ISSUE: ADD #1

PROJECT: **ODOT Maintenance Facility**
DIV 7 Walters, OK

ODOT MAINTENANCE FACILITY
DIVISION 7 - COTTON COUNTY
OKLAHOMA DEPARTMENT OF TRANSPORTATION
WALTERS, OKLAHOMA

DRAWN	J.T.H.
DESIGNED	J.T.H.
SURVEY	ODOT
JOB NO.	07056.03
REVISION	BY DATE
ADDED BOLT SPACING AND REVISED WELD SYMBOL	JTH 11/19/12
-	-
-	-
DATE	08/28/12
SHEET	S0.4

2 | DOOR FRAME TYPES
 1/4" = 1'-0"

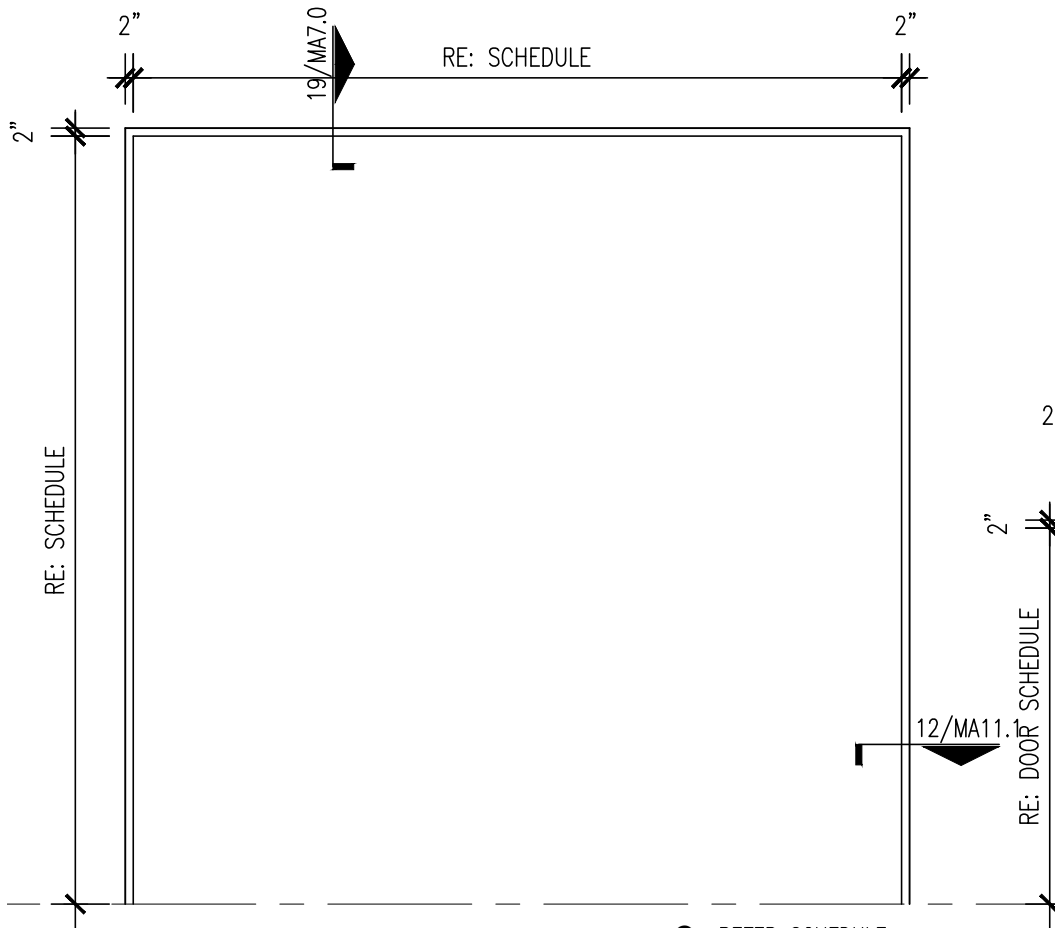
2 REFER SCHEDULE
 NOTE: COORDINATE O.H. DOOR PORTAL FRAME TO BE FLUSH W/ ADJACENT FRAME

STEEL CONNECTION DETAILS

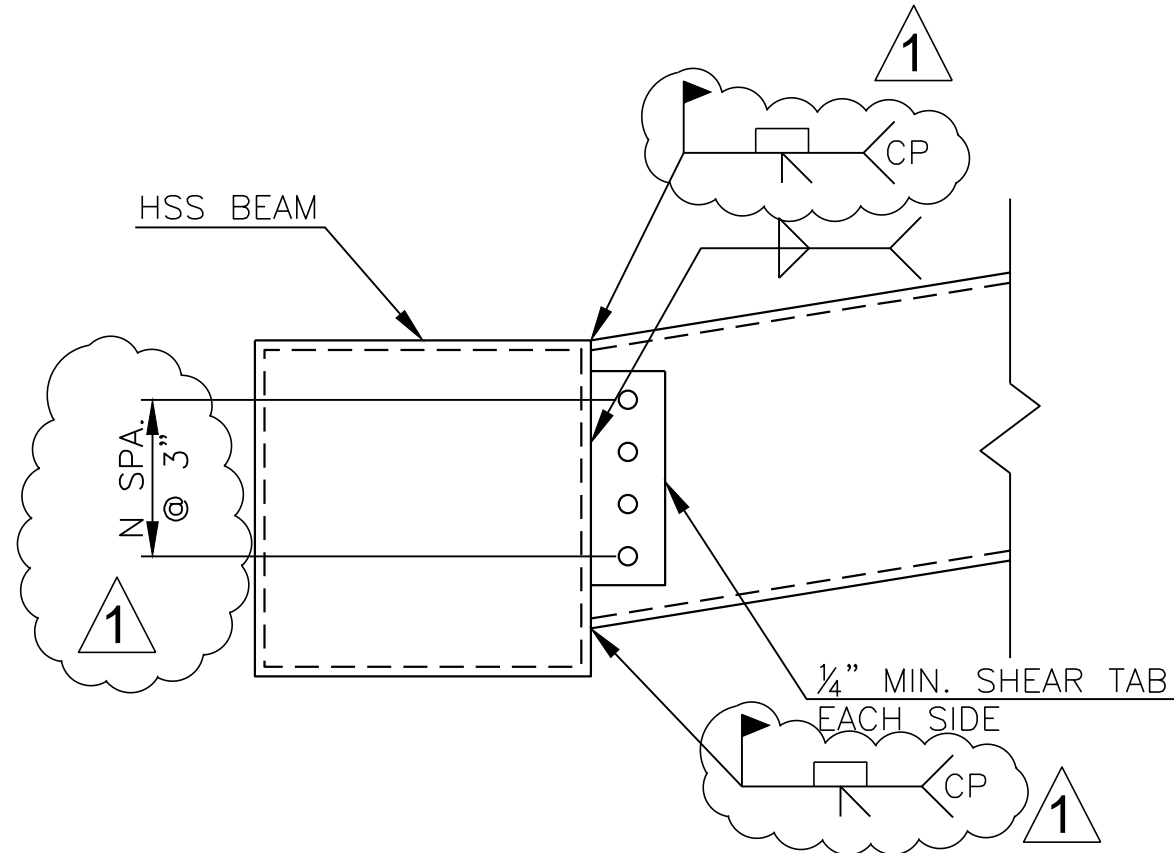
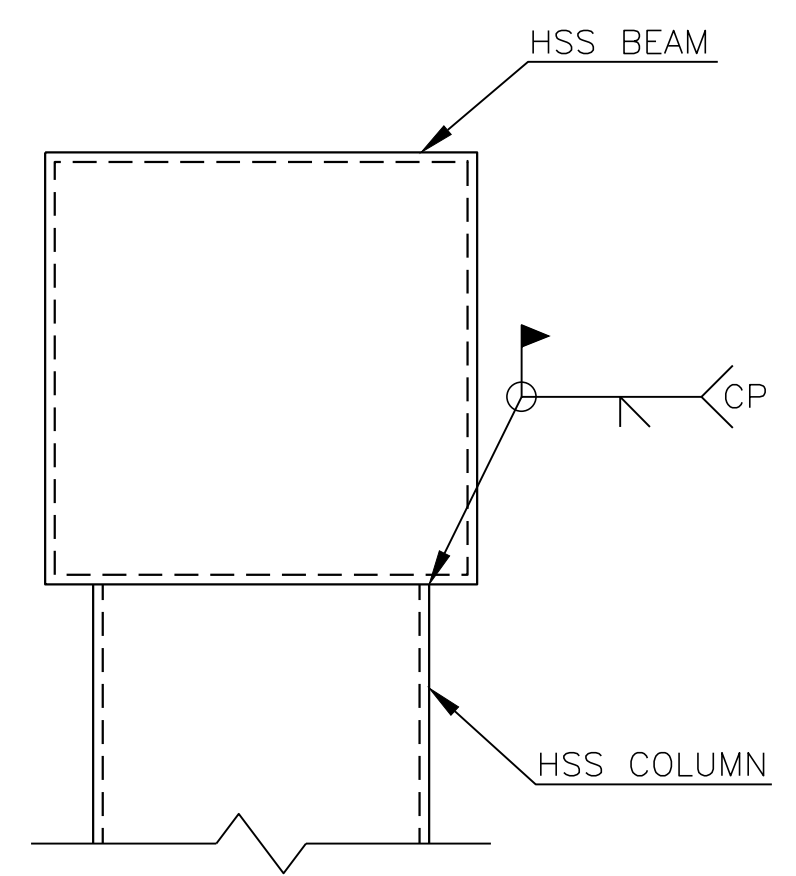
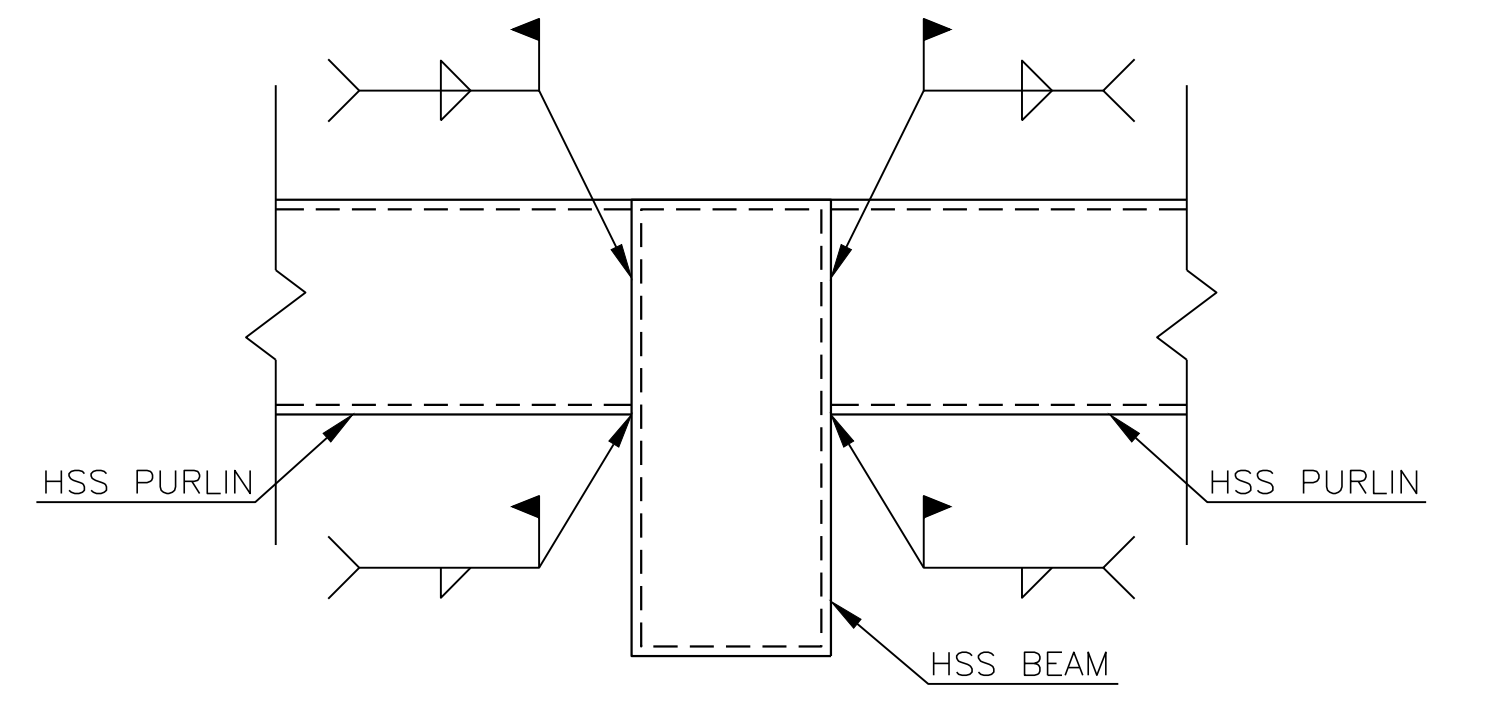
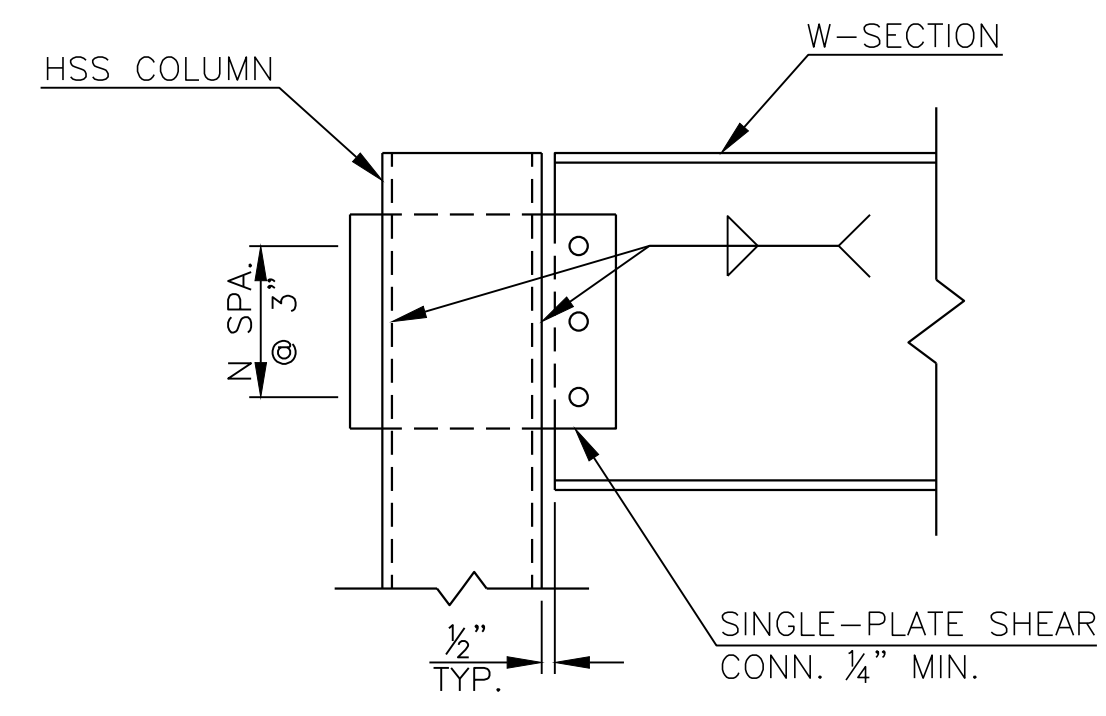
NOTE: FABRICATOR SHALL DESIGN CONNECTIONS AS SHOWN. REF. 6/SO.4 FOR SHEAR FORCE.
